City of Bay Minette

Planning Commission

AGENDA

PLANNING COMMISSION STAFF ANALYSIS

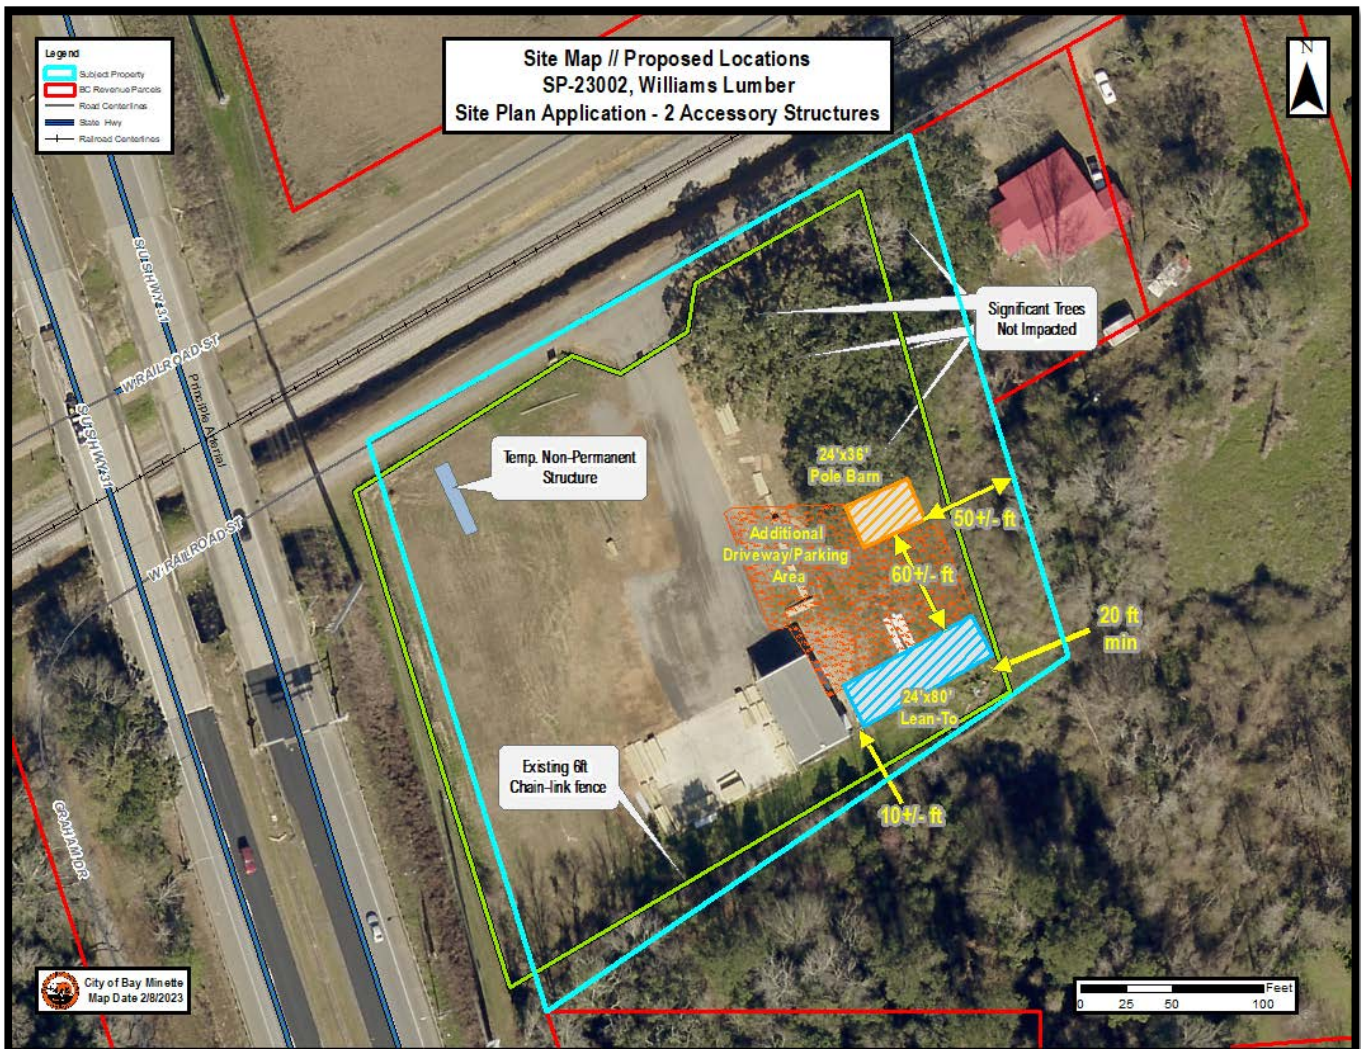
The proposed site plan shows a building footprint of 24'x36' (864 sq ft) for the pole barn which the applicant stated would have a 10ft eave height; and a 24'x80' (1,920 sq ft) lean-to with a front height of 16ft and angled back to the rear/south side. Both structures will be open storage - the pole barn will be roof only and the lean-to will have a wall on the south side.

For this property, the B-2 district requires 25ft front setbacks on local roads and there are no required setbacks for the side and rear yard except when abutting a residential district, the setback cannot be less than 20ft. The original site plan submitted shows setbacks that are not in compliance with this, however, the applicant has stated that the lean-to will be 20ft or more from the rear property line. The side setback dimensions shown on the site plan ranging from 5' to 15' are stating the distance from the existing chain-link fence, which is shown approximately 37' from the property line as estimated from GIS. The graphics included in this section were created by staff to approximate the proposed locations for existing site features and proposed structures. It is an estimate based on submittals and communication with the applicant intended to provide an illustrated guide to assist the Planning Commission.

The illustrations show a potential conflict with the pole barn and existing trees. Based on the revisions to the submitted site plans and clarification needed for structure location and final driveway/parking area size, staff would recommend that the applicant submit a Site Plan detailing final locations and dimensions at the time of Building Permit application.

- 1.) Submittal of a Site Plan detailing final locations and dimensions for staff review prior to the issuance of a Building Permit.
- 2.) The issuance of a Building Permit be contingent upon access review by ALDOT or the City Engineer based on ALDOT's review and determination of access authority.

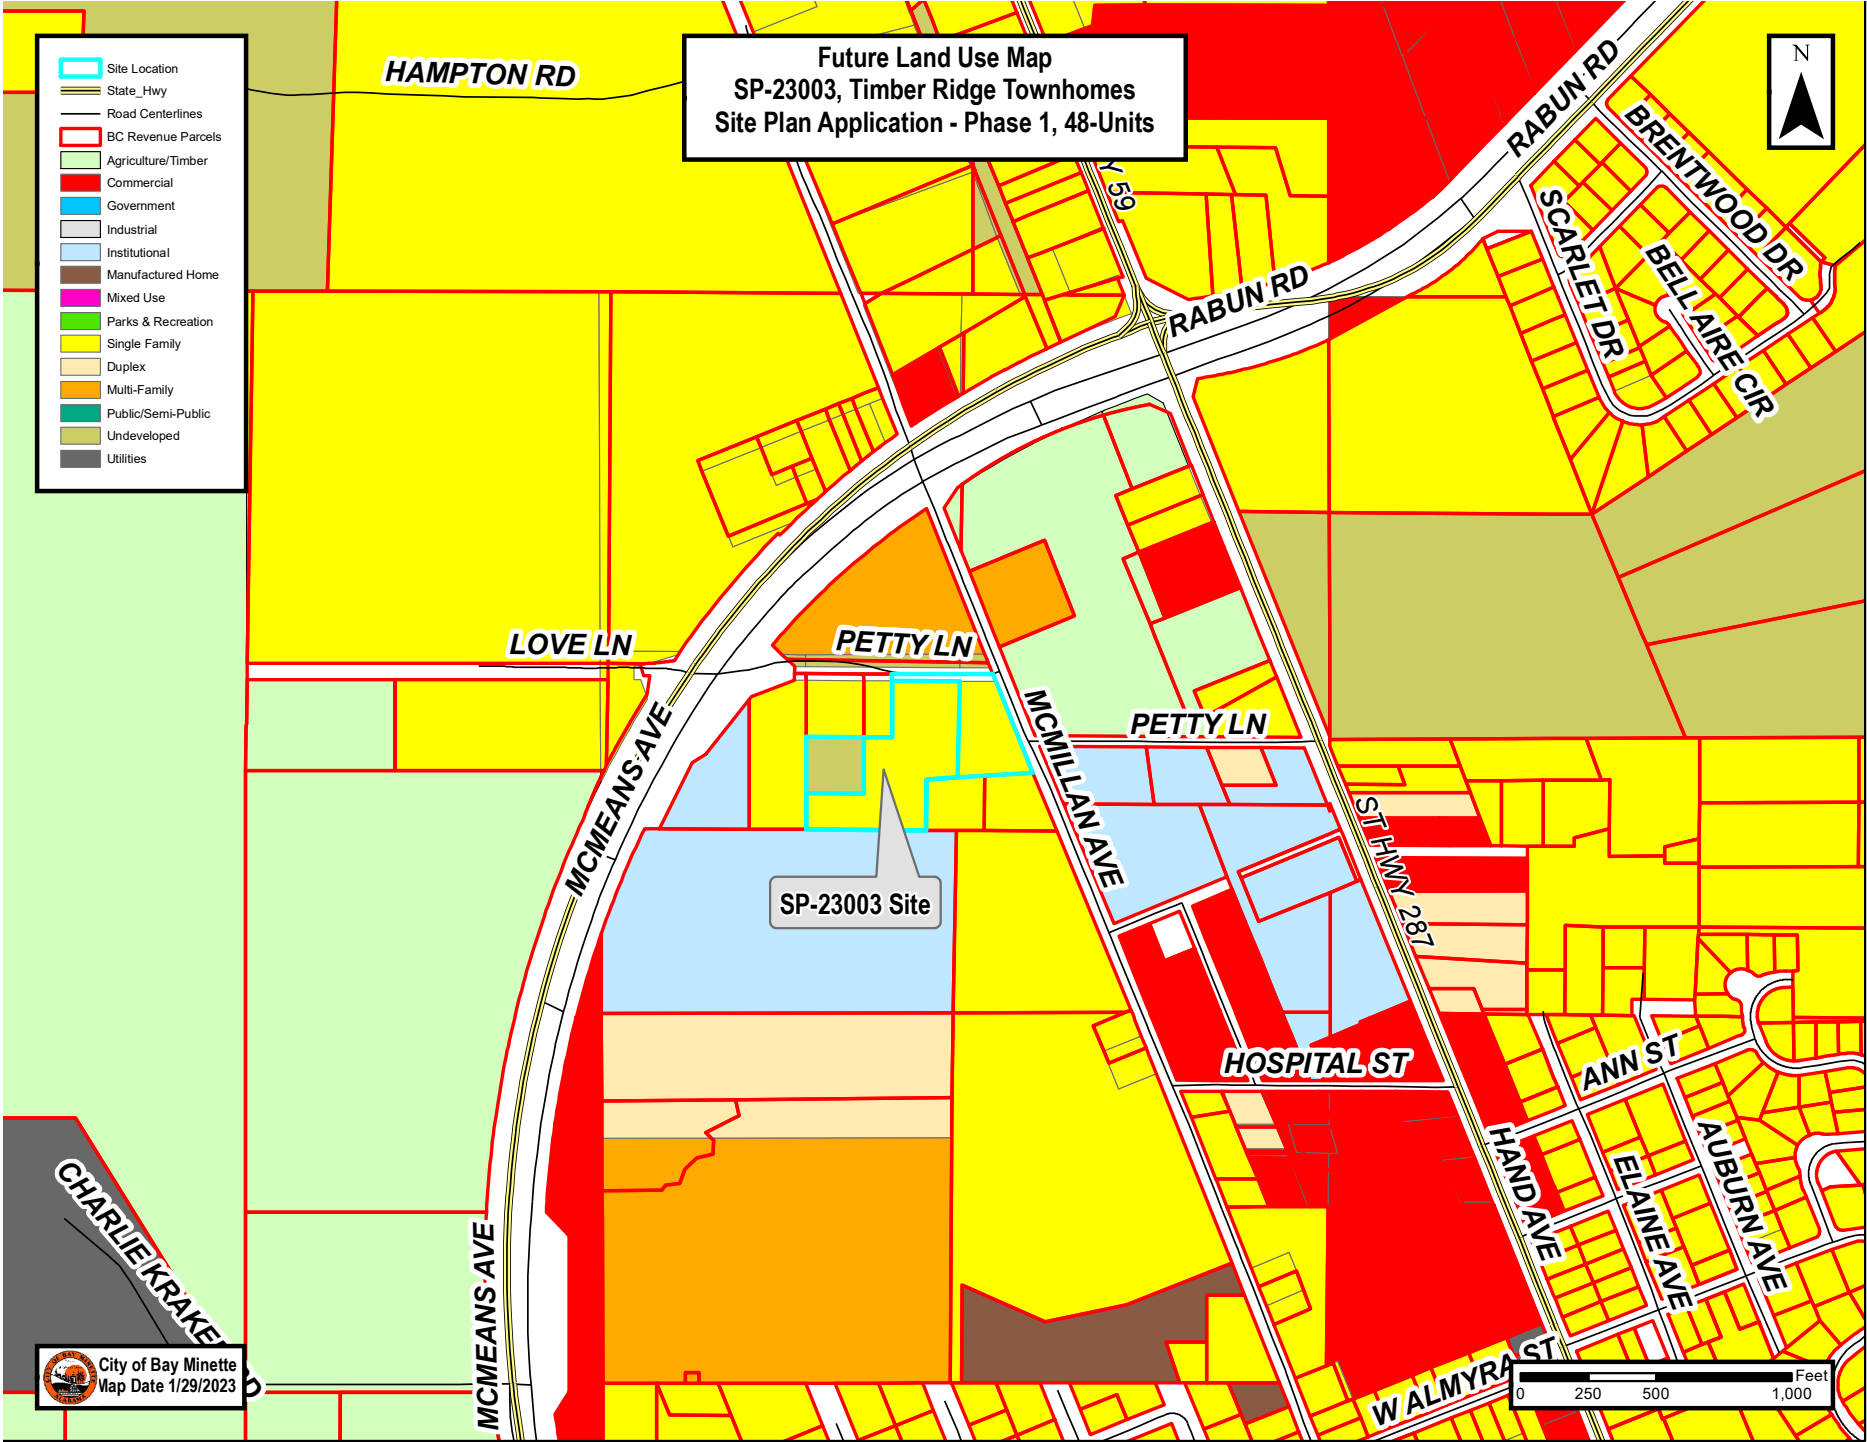
Baldwin County E-911 – Noted that the Site Plan labels Petty Ln as “New Petty Lane” and stated that this would need to be fixed to show just Petty Ln. Also noted that addressing plans for the site will require coordination between City Planning & Fire Dept staff with E-911.

The 8-ft fence proposed exceeds the 7-ft maximum height for fencing in residential areas (*Sec 7.16.5.2*), however, *Sec 10.12* does authorize the Planning Commission to impose additional standards/more stringent designs related to landscape standards that may ensure compatibility with surrounding properties and benefit aesthetics.

- 1.) Grading, drainage, utility and life-safety plans for review and approval by the Building Official, Fire Inspector and City Engineers.

- 2.) Plans satisfying the provisions for the disposition of open space and off-street parking landscaping provisions, prior to the issuance of a building permit.
